Access Compliance Report

Public Rights-of-Way

(Pedestrian Signals)

Intersection ID: N/A	Main Street:	Cross Street: N/A	Location: N/A
ADA ID: E0C6A3618019	Signal Type: One Push Button-Non APS	Overall Compliance: No	Severity Score: BTN 1: N/A BTN 2: N/A No BTN: N/A
Codes/Mitigation Info/Possible Solution		Field Measurements/Component Compliance

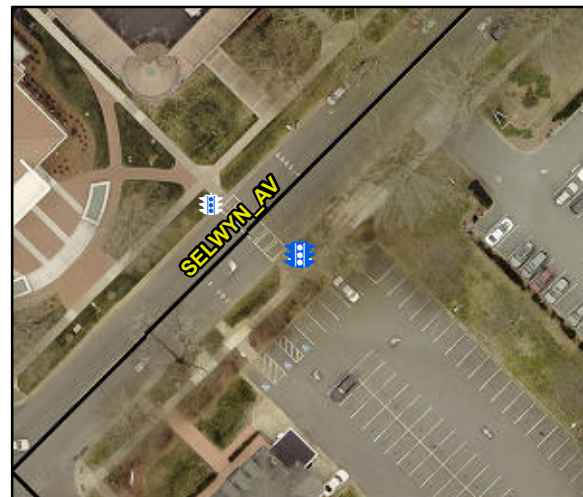
Compliance	Description	Data	Compliance	Description	Data
	Button Count	Button1	N/A	Distant to Additional Button (in)	N/A
	Additional Button Present?	No		Additional Button ID	N/A
N/A	Signal Buttons Required?	N/A	N/A	Additional Ped Posts Required	N/A
	How Many Ped Street Xings?	1		Located In An Island/Median?	No
N/A	B 1 Sign Present?	Yes	N/A	B 2 Sign Present?	N/A
Yes	B 1 Sign Purpose?	Yes	N/A	B 2 Sign Purpose?	N/A
No	B 1 Sign Lettering & Contrast?	No	N/A	B 2 Sign Lettering & Contrast?	N/A
Yes	B 1 Parallel To XWalk?	Yes	N/A	B 2 Parallel To XWalk?	N/A
Yes	B 1 PAR to Button?	Yes	N/A	B 2 PAR to Button?	N/A
Yes	B 1 PAR to XWalk?	Yes	N/A	B 2 PAR to XWalk?	N/A
Yes	B 1 Clear Floor Space?	Yes	N/A	B 2 Clear Floor Space?	N/A
N/A	B 1 FWD Approach?	Yes	N/A	B 2 FWD Approach?	N/A
N/A	B 1 FWD Approach Constrained?	No	N/A	B 2 FWD Approach Constrained?	N/A
No	B 1 FWD Approach Reach (in)	5.0	N/A	B 2 FWD Approach Reach (in)	N/A

N/A	B 1 FWD Approach Width (in)	N/A	N/A	B 2 FWD Approach Width (in)	N/A
N/A	B 1 FWD Approach Obstruction?	Yes	N/A	B 2 FWD Approach Obstruction?	N/A
N/A	B 1 FWD Approach Obstruction Dist (in)	3.0	N/A	B 2 FWD Approach ObstructionDist (in)	N/A
N/A	B 1 PARA Approach?	Yes	N/A	B 2 PARA Approach?	N/A
N/A	B 1 PARA Approach Constrained?	No	N/A	B 2 PARA Approach Constrained?	N/A
Yes	B 1 PARA Approach Reach (in)	5.0	N/A	B 2 PARA Approach Reach (in)	N/A
N/A	B 1 PARA Approach Width (in)	N/A	N/A	B 2 PARA Approach Width (in)	N/A
N/A	B 1 PARA Approach Obstruction?	Yes	N/A	B 2 PARA Approach Obstruction?	N/A
N/A	B 1 PARA Approach Obstruction Dist (in)	3.0	N/A	B 2 PARA Approach ObstructionDist (in)	N/A
No	B 1 Clear Floor Space Slope (%)	4.4	N/A	B 2 Clear Floor Space Slope (%)	N/A
Yes	B 1 Clear Floor Space XSlope (%)	1.9	N/A	B 2 Clear Floor Space XSlope (%)	N/A
N/A	B 1 PAR Slope (%)	3.9	N/A	B 2 PAR Slope (%)	N/A
Yes	B 1 Height (in)	41.0	N/A	B 2 Height (in)	N/A

Yes B 1 Clear Xing Direction?	ClearlyMarked	N/A B 2 Clear Xing Direction?	N/A
B 1 Crossing Direction	To NW	B 2 Crossing Direction	N/A
Yes B 1 DistanceTo XWalk (in)	0.0	N/A B 2 DistanceTo XWalk (in)	N/A
No B 1 DistanceTo Curb (in)	15.0	N/A B 2 DistanceTo Curb (in)	N/A
Yes B 1 Diameter (in)	2.0	N/A B 2 Diameter (in)	N/A

Possible Solutions: Replace Signal Push Button With APS Button on New Post. Remove & Replace Sign.
